**SUBJECT:** **NEW VEHICLE DEMONSTRATION / DELIVERY HOLD**  
**Safety Recall 23S35 - Supplement # 2**  
 Certain 2021-2023 Model Year F-150 Vehicles with Single Exhaust  
 Repair Rear Axle Wire Harness Chafe

## CERTAIN 2021-2023 MODEL YEAR F-150 VEHICLES EQUIPPED WITH SINGLE EXHAUST — REAR WHEEL SPEED SENSOR HARNESS REWORK

### **NEW !** SERVICE PROCEDURE

FIGURE 1

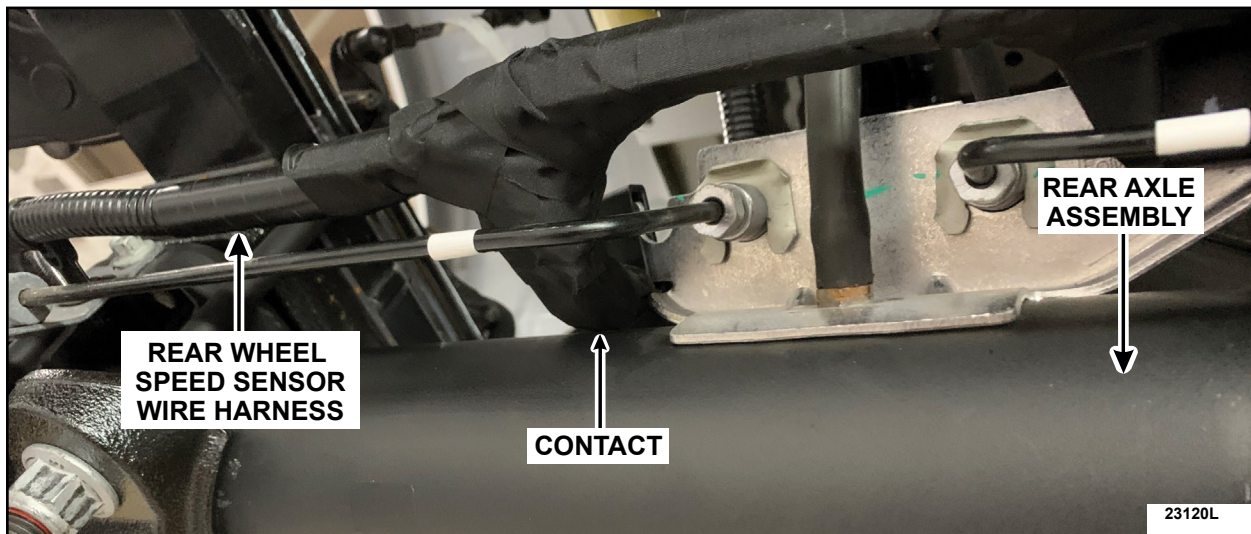
1. *Raise the vehicle on a hoist. Follow the Workshop Manual (WSM) procedures in section 100-02.*
2. *Locate the vehicles existing Electronic Park Brake (EBP) wiring harness, above the rear axle assembly. Use a clean wet shop rag (mixed with water) and clean the wire harness contact location and the full circumference of the wire harness. Allow the water to dry before any tape application.*

**NOTE:** *The surface needs to be clean, to allow for the new wiring tape (Polyken 650) that is being applied in this repair, in order to properly adhere to the existing wire harness. See Figure 1.*

**FIGURE 7**

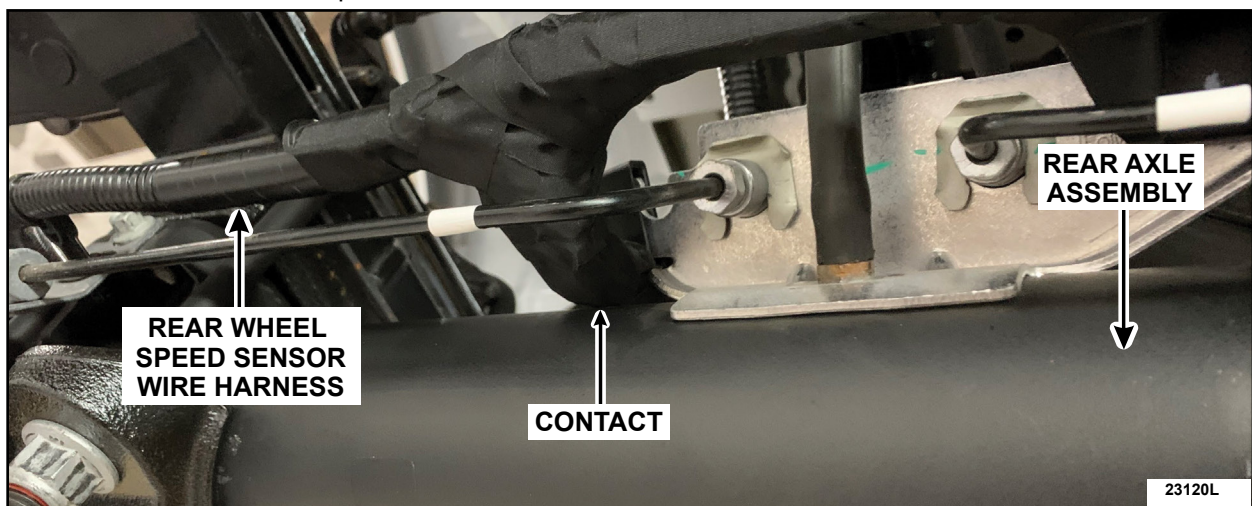
9. Is the rear wheel speed wire harness tape near the contact location worn completely through to the harness? See Figure 7.

*YES - Install a new rear axle wire harness (Base Part # 15K857) Follow the WSM procedures in Section 206-09. This completes this Recall. Proceed to step 15.*

*NOTE: Replacement rear axle wire harness are specific to the vehicle build combination. Refer to the Dealer Bulletin to order the correct wiring harness.*

NO - Proceed to Step 10.

**FIGURE 9**

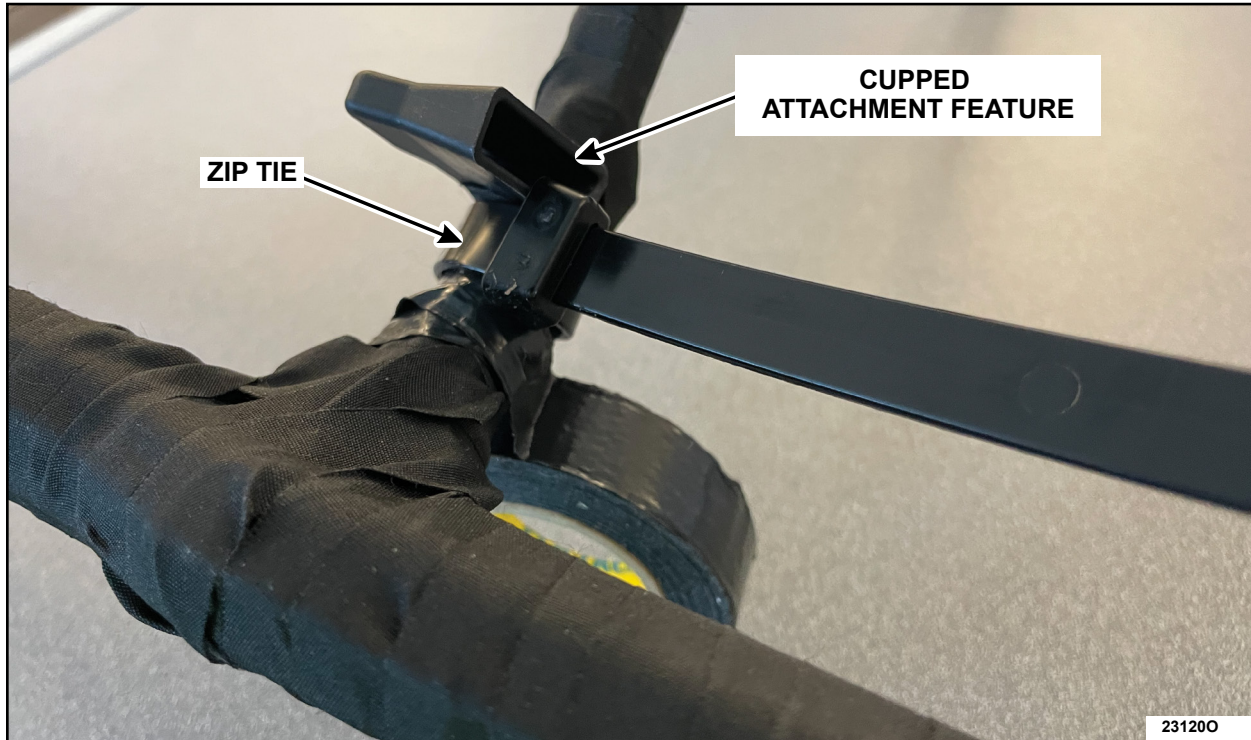
11. Place and tighten the zip tie as close as possible to the cupped attachment feature on the shield.  
See Figure 9.

**NOTE:** The head of the zip tie will overlap the edge on the shield that is under the tape in the harness.

**NOTE:** This zip-tie is used for extra anti-abrasion between the axle and wire harness and not to be captured to any other components.

**FIGURE 11**

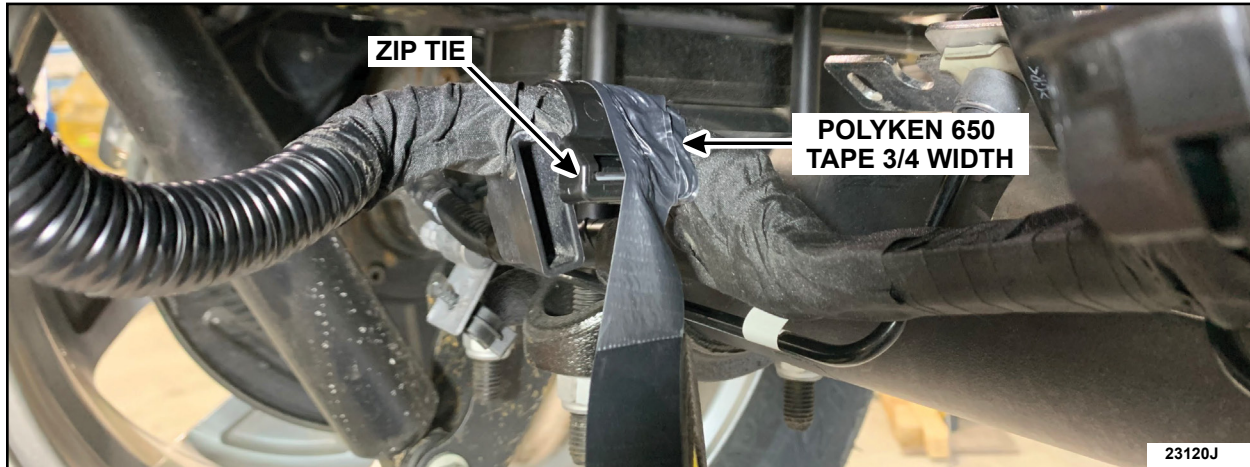
13. Pull the takeout harness rearward and apply Polyken 650 tape 3/4 width at the forward edge of the zip tie. Anchor tape to wire harness with two loops of tape, then apply four or more wraps of tape, making sure to overlap half of the zip tie. See Figure 11.
